No.	Date	Description
1	2025-09-19	Add No. 1
2	2025-09-30	Add No. 2

**WCFPD Station 3**  
**Wright City Fire Protection District**  
9 Highway WW  
Wright City, MO 63390

ONSITE  
WASTEWATER  
TREATMENT PLAN

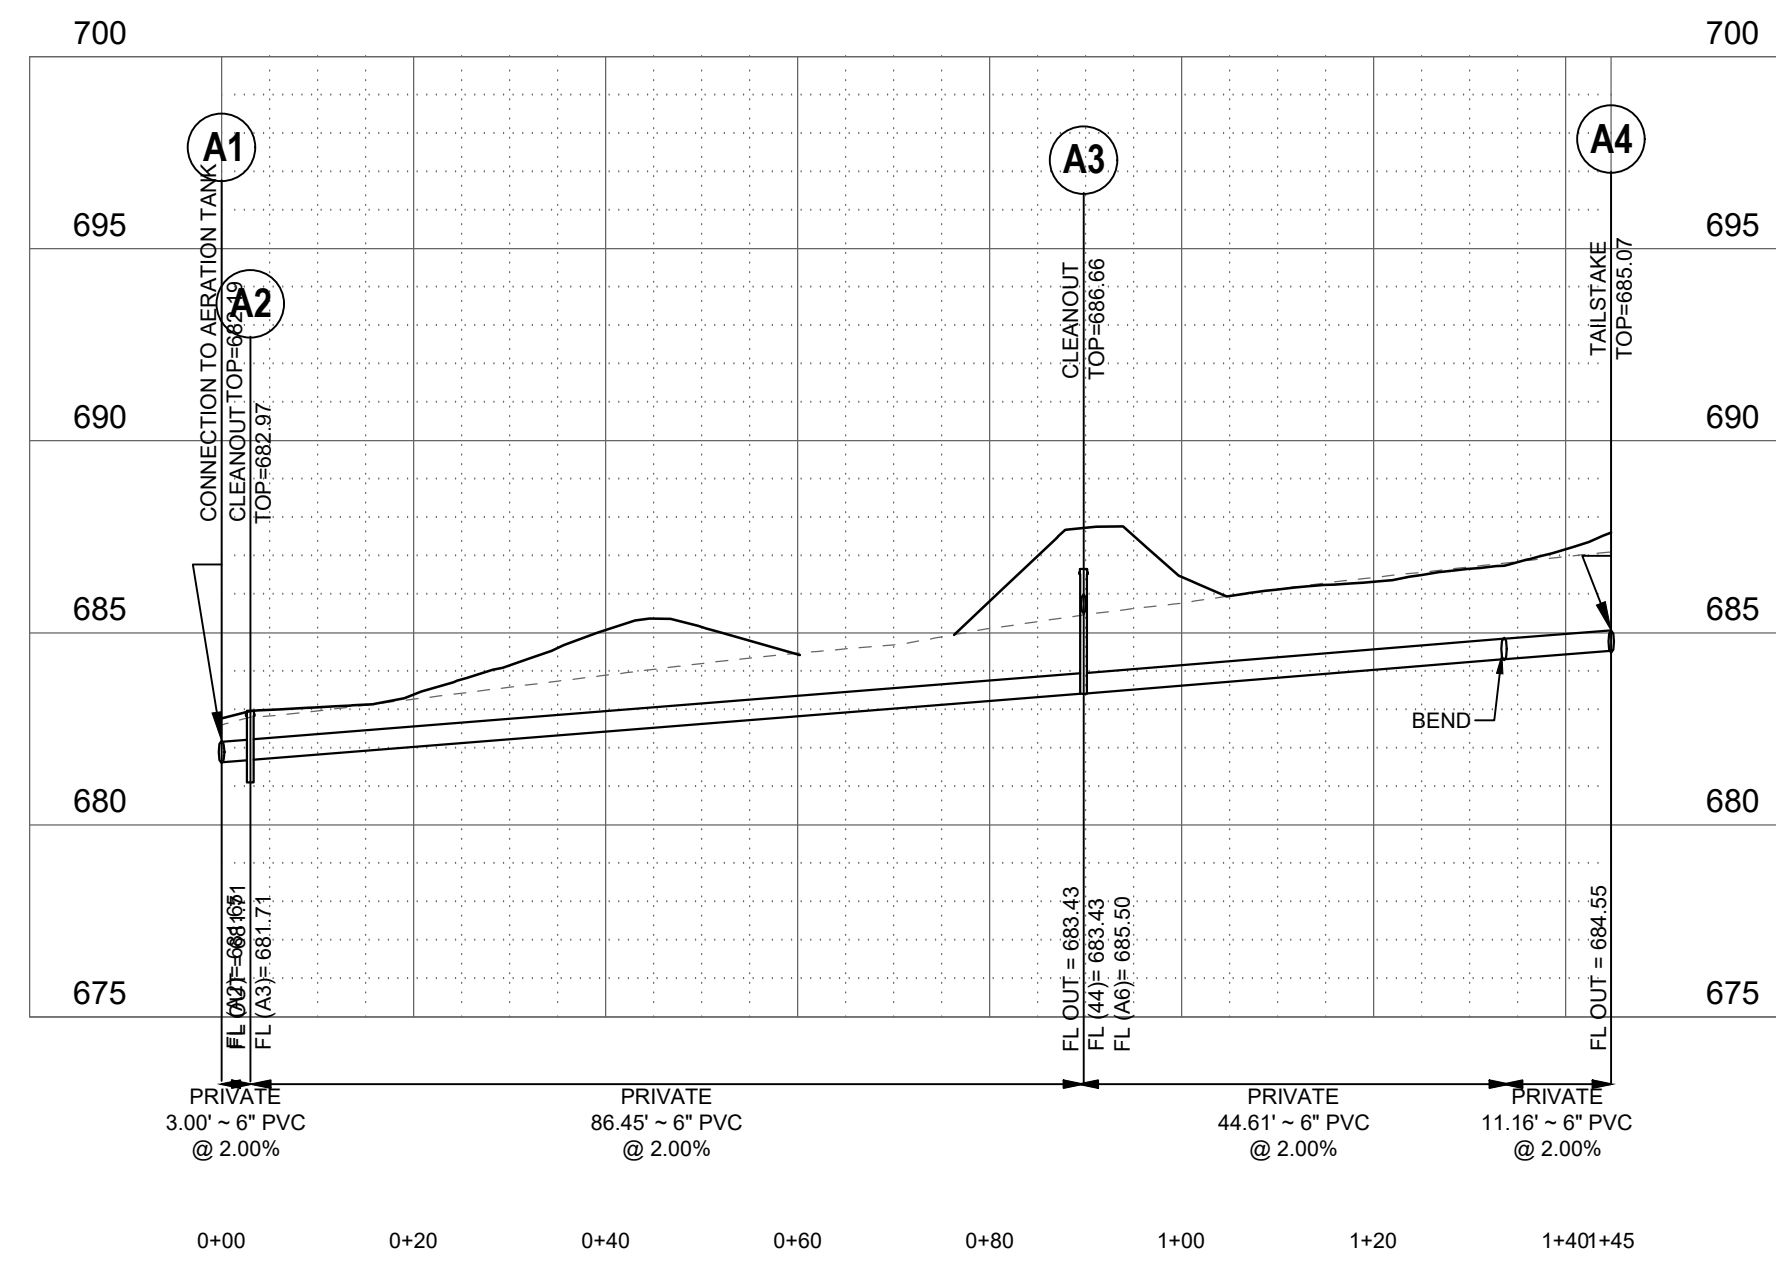
- 9) Sheet C501 – ONSITE WASTEWATER TREATMENT PLAN
  - a. ADD new sheet.
- 10) Sheet C600 – SEWER PROFILES
  - a. REVISED the profile for the storm 3 run with the new ADS inlet.

1 Life Safety Plan  
 LS101 1/4" = 1'-0"

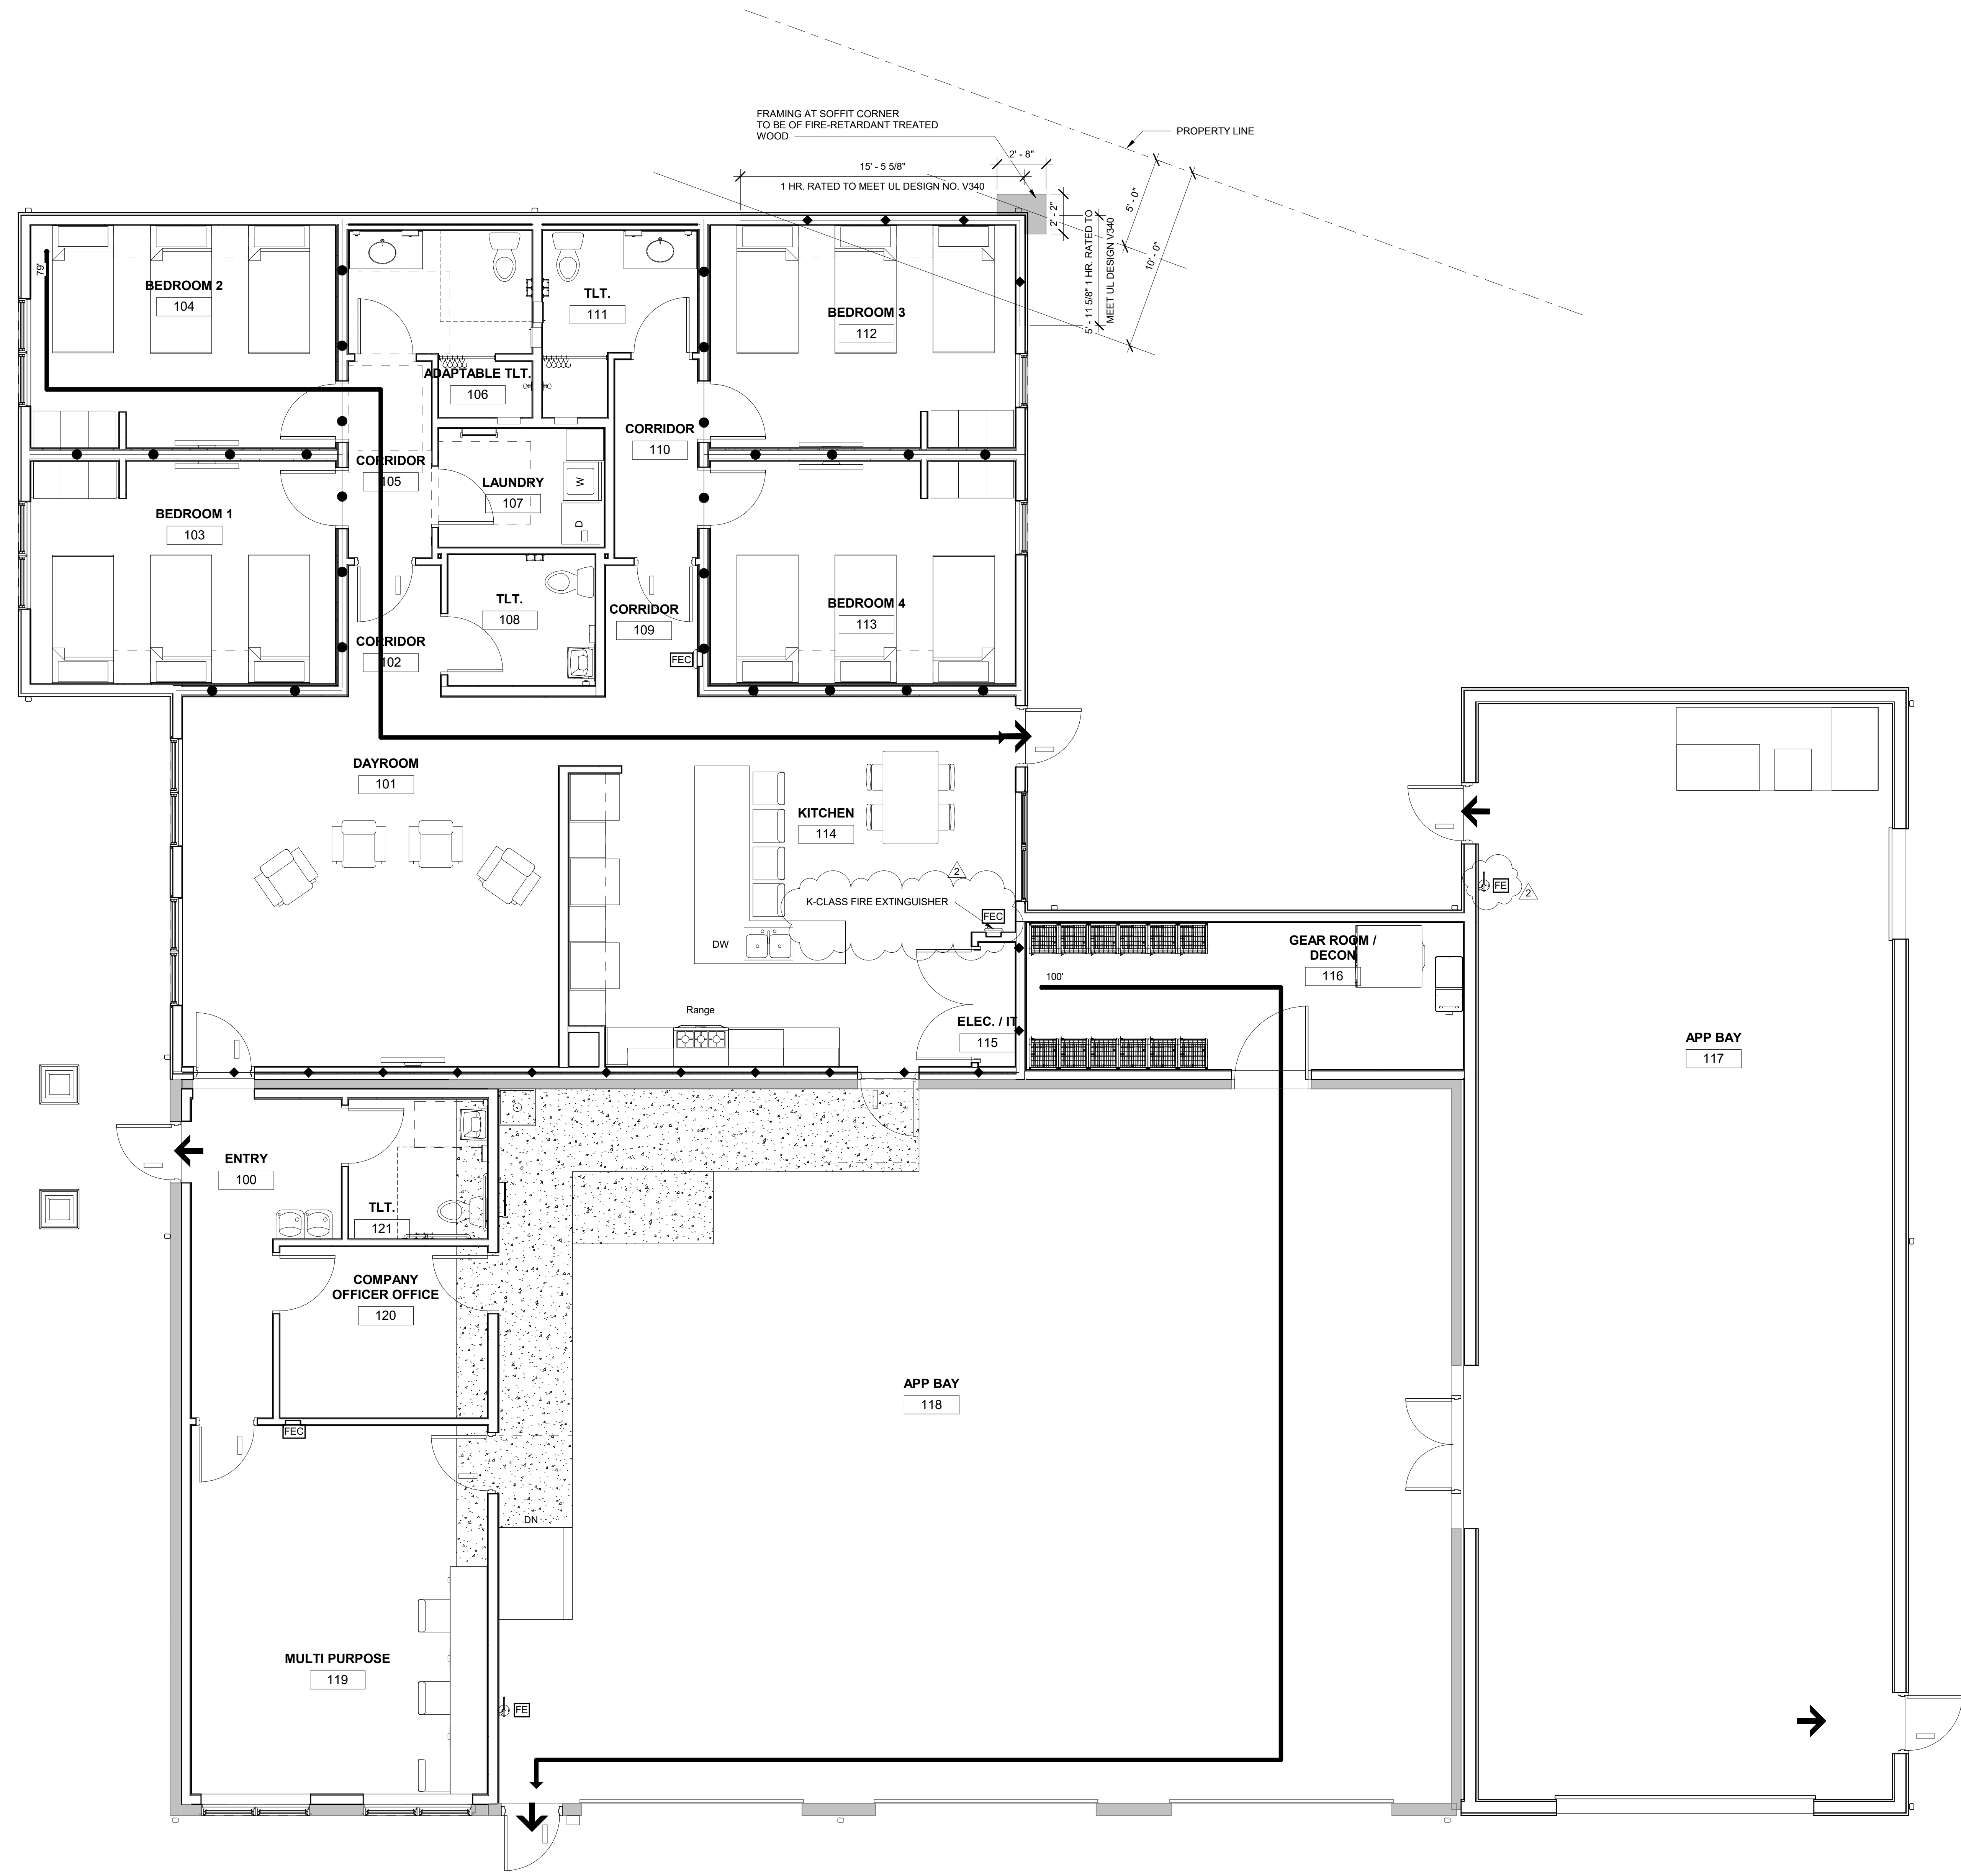
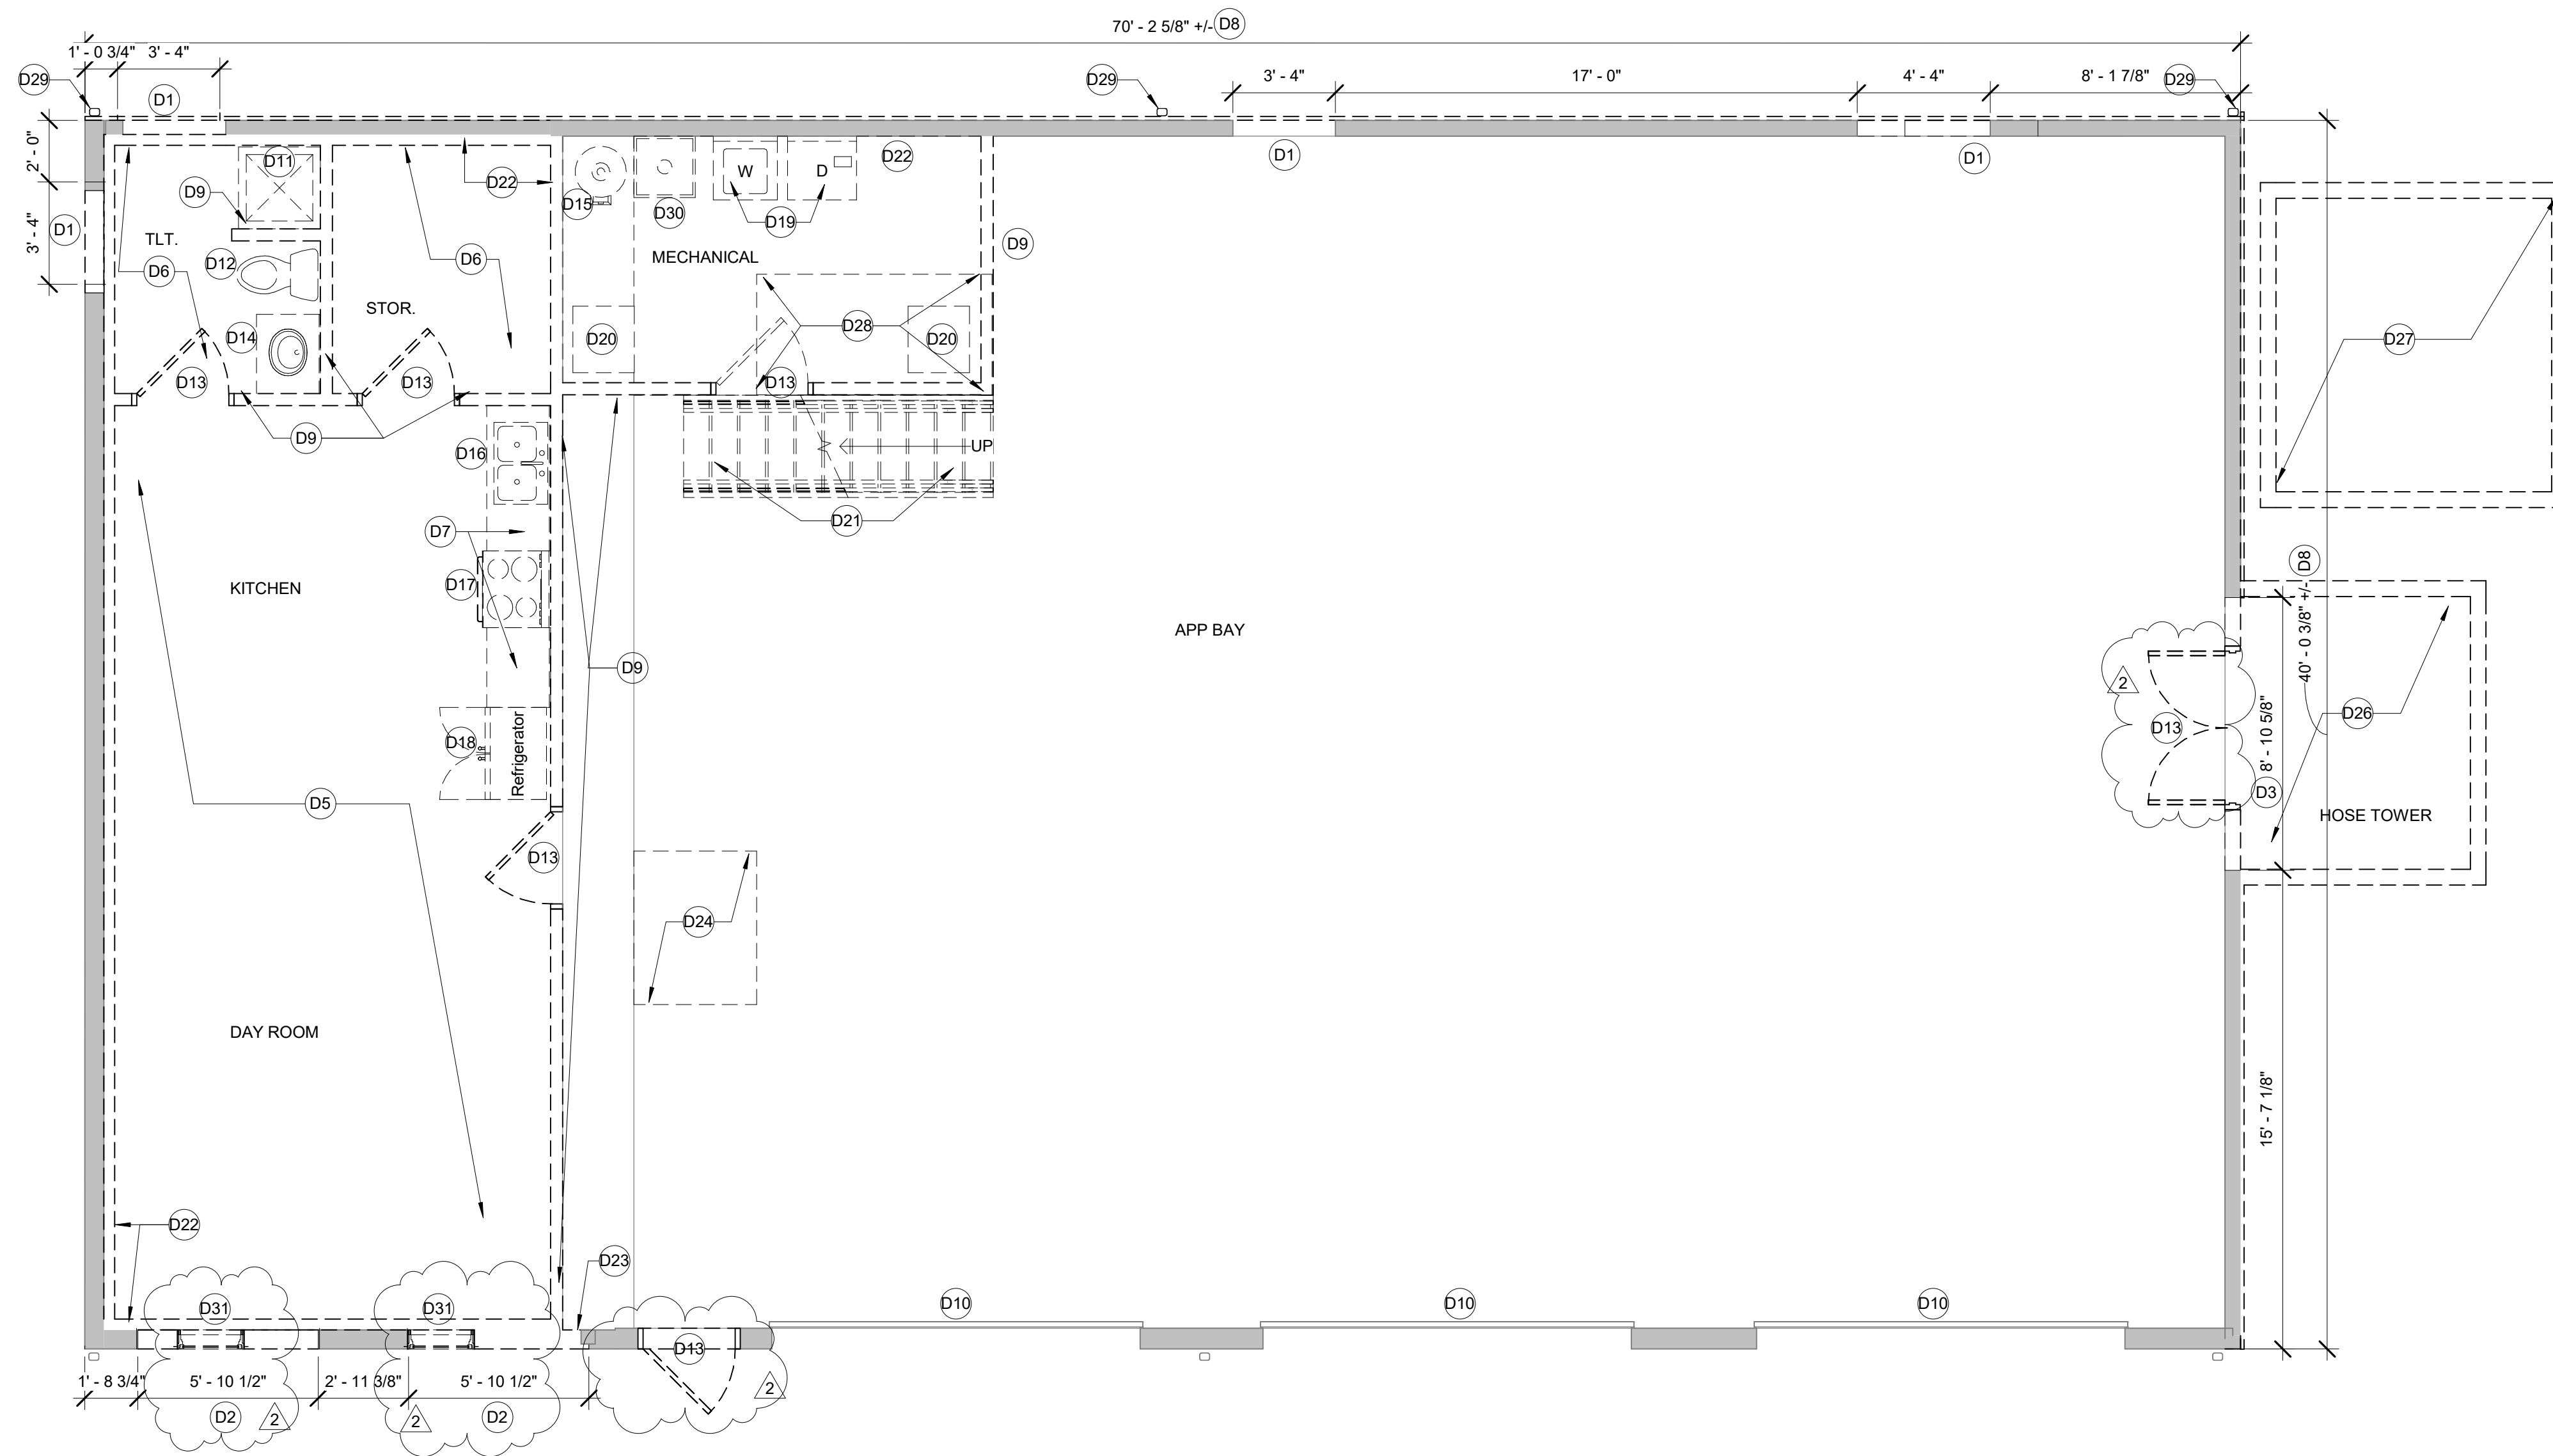
- a. ADD new details.
- 13) Sheet LS101 – LIFE SAFETY PLAN
  - a. ADD a K-class fire extinguisher and cabinet in the kitchen.
  - b. ADD a wall mounted fire extinguisher in the North end of App Bay 117.
